AGENDA
HAILEY PLANNING & ZONING COMMISSION
Tuesday, September 7, 2021
In-Person and Virtual Meeting
5:30 p.m.

PH 1 Consideration of a Design Review Application by Jason Szabo and Christian Wrede represented by Mountain Wood Construction, for a detached garaged to be located at 303 North 4th Avenue (Lot 911, Block 49, Hailey Townsite) within the Limited Residential 1 (LR 1) and Hailey Townsite Zoning Districts. **ACTION ITEM.**

PH 2 Consideration of a Design Review Application by Jason Szabo and Christian Wrede represented by Mountain Wood Construction, for a detached garaged to be located at 305 North 4th Avenue (Lot 9A, Block 49, Hailey Townsite) within the Limited Residential 1 (LR 1) and Hailey Townsite Zoning Districts. **ACTION ITEM.**

PH 3 Consideration of a Preapplication Design Review by Scott Miley (Leargulf LLC), represented by Gardenspace Design, for a project titled Tommy's Holiday Camp consisting of a commercial recreational facility with eight (8) short-term rental cabins, one (1) 912 square foot community building, one (1) 912 square foot managers unit and five (5) van-camp parking spaces. The project includes landscaping, patio and outdoor play area. This project

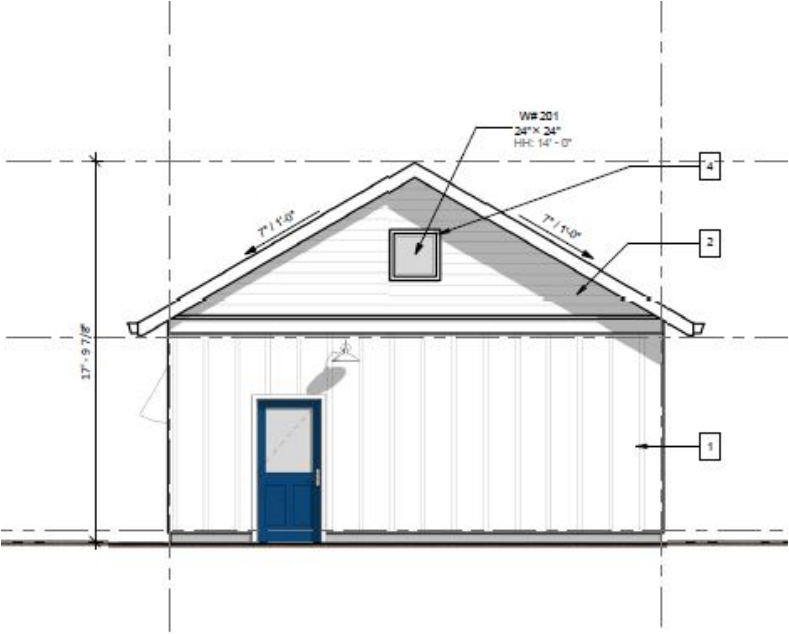
<input checked="" type="checkbox"/>	<input type="checkbox"/>	<input type="checkbox"/>	17.06.090(C)3d	<p>Guideline: Roof pitch and style shall be designed to meet snow storage needs for the site.</p> <ul style="list-style-type: none"> • Roof pitch materials and style shall retain snow on the roof, or allow snow to shed safely onto the property, and away from pedestrian travel areas. • Designs should avoid locating drip lines over key pedestrian routes. • Where setbacks are less than ten feet, special attention shall be given to the roof form to ensure that snow does not shed onto adjacent properties.

<i>Staff Comments</i>	<i>Asphalt shingles will be installed to match that of the existing residence. The Applicant can better describe gutters and/or other snow retention devices utilized.</i>
<input checked="" type="checkbox"/>	<input type="checkbox"/>	<input type="checkbox"/>	17.06.090(C)3d	<p>Guideline: The use of roof forms, roof pitch, ridge length and roof materials that are similar to those traditionally found in the neighborhood are encouraged.</p>
			<i>Staff Comments</i>	<i>The proposed addition is compact and incorporates a simple shed roof, which will complement the existing residence. The proposed roof forms, ridge lengths and materials are similar to those traditionally found in the neighborhood.</i>
<input checked="" type="checkbox"/>	<input type="checkbox"/>	<input type="checkbox"/>	17.06.090(C)3d	<p>Guideline: The roof pitch of a new building should be compatible with those found traditionally in the surrounding neighborhood.</p>

17.06.090(C)3i	i. Ornamentation and Architectural Detailing

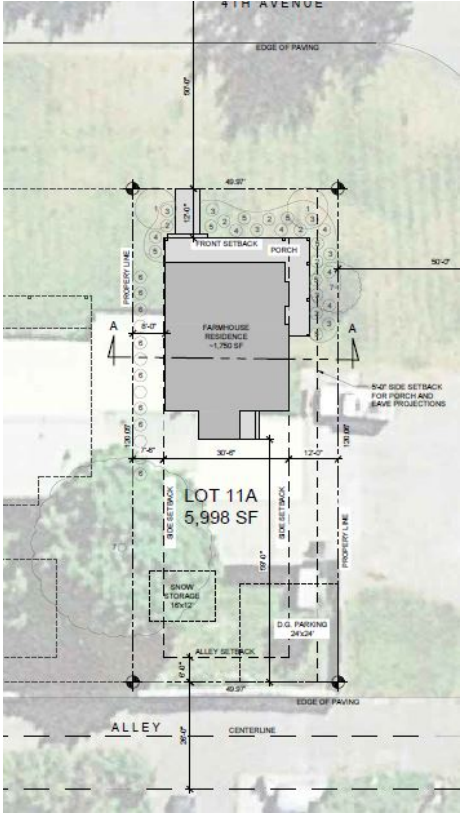
<input checked="" type="checkbox"/>	<input type="checkbox"/>	<input type="checkbox"/>	17.06.090(C)3h	Guideline: Large wall planes shall incorporate more than one material or color to break up the mass of the wall plane.
			Staff Comments	<i>The proposed garage is square and sees equal lengths on all sides. Wall planes are broken up by various exterior materials, windows and a door. Siding colors will vary from the entry door, which will help reduce the mass of the wall planes.</i>

<input checked="" type="checkbox"/>	<input type="checkbox"/>	<input type="checkbox"/>		Guideline: Architectural detailing shall be incorporated into the front wall plane of buildings.
			Staff Comments	<i>Simple detailing is proposed: door trim, windows, and plank siding. Detail will match that of the existing residence.</i>
<input checked="" type="checkbox"/>	<input type="checkbox"/>	<input type="checkbox"/>	17.06.090(C)3i	Guideline: The use of porches, windows, stoops, shutters, trim detailing and other ornamentation that is reminiscent of the historic nature of Old Hailey is encouraged.
			Staff Comments	<i>The existing residence has minimal ornamentation. Simple detailing is proposed to complement that of the existing residence: various windows, and vertical and horizontal siding.</i>
<input checked="" type="checkbox"/>	<input type="checkbox"/>	<input type="checkbox"/>	17.06.090(C)3i	Guideline: Architectural details and ornamentation on buildings should be compatible with the scale and pattern of the neighborhood.

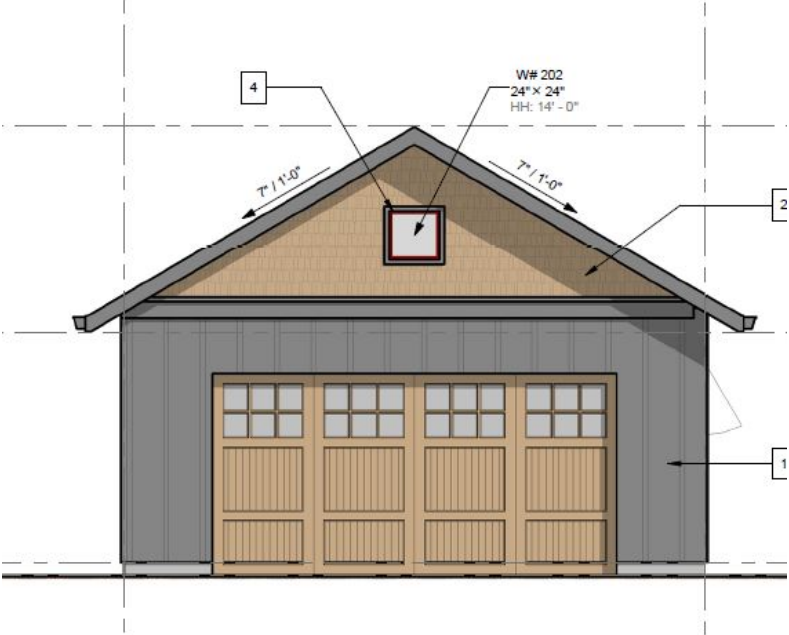
<input type="checkbox"/>	<input type="checkbox"/>	<input checked="" type="checkbox"/>	17.06.090(C)3g	Guideline: Decks and balconies should be designed with the privacy of neighbors in mind when possible.
			Staff Comments	<i>N/A, as no decks or balconies are proposed.</i>
<input checked="" type="checkbox"/>	<input type="checkbox"/>	<input type="checkbox"/>	17.06.090(C)3h	h. Building Materials and Finishes
				Guideline: Materials and colors shall be selected to avoid the look of large, flat walls. The use of texture and detailing to reduce the perceived scale of large walls is encouraged.

Staff Comments	<p>The proposed addition sees simple forms. Exterior materials of the proposed addition will complement that of the existing residence. All proposed siding is of Board and Batt siding, painted (Night Gray) to match that of the existing residence. Hardie shingles will also be incorporated and painted Khaki Brown. The garage doors will be painted brown to match that of the shingles and existing residence, and the roof will be of asphalt shingles, which are consistent with styles and forms found in Old Hailey (see image below for further detail).</p> 
<input checked="" type="checkbox"/>	<input type="checkbox"/>	<input type="checkbox"/>	17.06.090(C)3h	<p>Guideline: Large wall planes shall incorporate more than one material or color to break up the mass of the wall plane.</p> <p>Staff Comments The proposed garage is square and sees equal lengths on all sides. Wall planes are broken up by various exterior materials, windows and a door. Siding colors will vary from the garage door and entry door, which will help reduce the mass of the wall planes.</p>

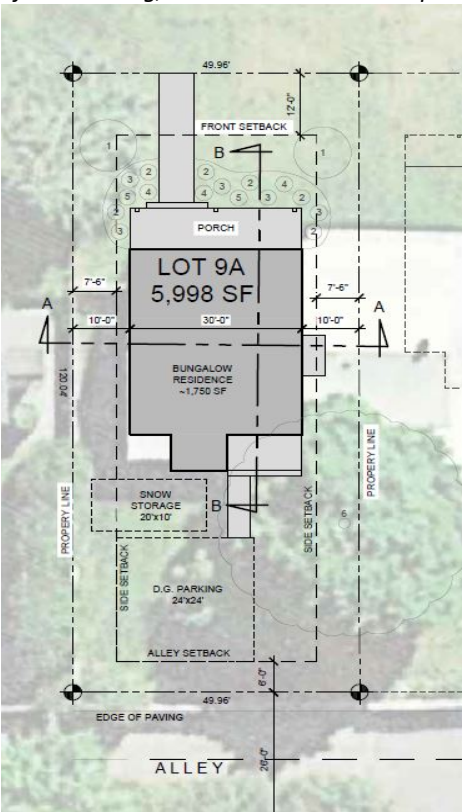
<input checked="" type="checkbox"/>	<input type="checkbox"/>	<input type="checkbox"/>	17.06.090(C)4	<p>4. Circulation and Parking</p> <p>Guideline: Safety for pedestrians shall be given high priority in site planning, particularly with respect to parking, vehicular circulation and snow storage issues.</p> <p>Staff Comments Adequate parking has been provided. Pedestrian access is provided with the proposed concrete pathway from the residence to the proposed garage. A</p>

<p>pathway to the front entry of the residence is existing. Snow storage areas are located to the rear of the building, which does not restrict pedestrian access.</p> 
<input checked="" type="checkbox"/>	<input type="checkbox"/>	<input type="checkbox"/>	17.06.090(C)4	<p>Guideline: The visual impacts of on-site parking visible from the street shall be minimized.</p> <p><i>Staff Comments</i> Onsite parking will be accessed from the alley side of the property and is blocked from the street by the existing residence.</p>
<input checked="" type="checkbox"/>	<input type="checkbox"/>	<input type="checkbox"/>	17.06.090(C)4	<p>Guideline: As a general rule, garages and parking should be accessed from the alley side of the property and not the street side.</p> <p><i>Staff Comments</i> The proposed garage addition will be accessed from the alley.</p>
<input checked="" type="checkbox"/>	<input type="checkbox"/>	<input type="checkbox"/>	17.06.090(C)4	<p>Guideline: Detached garages accessed from alleys are strongly encouraged.</p> <p><i>Staff Comments</i> The proposed garage will be detached from the primary residence. It will also be accessed from the alley.</p>
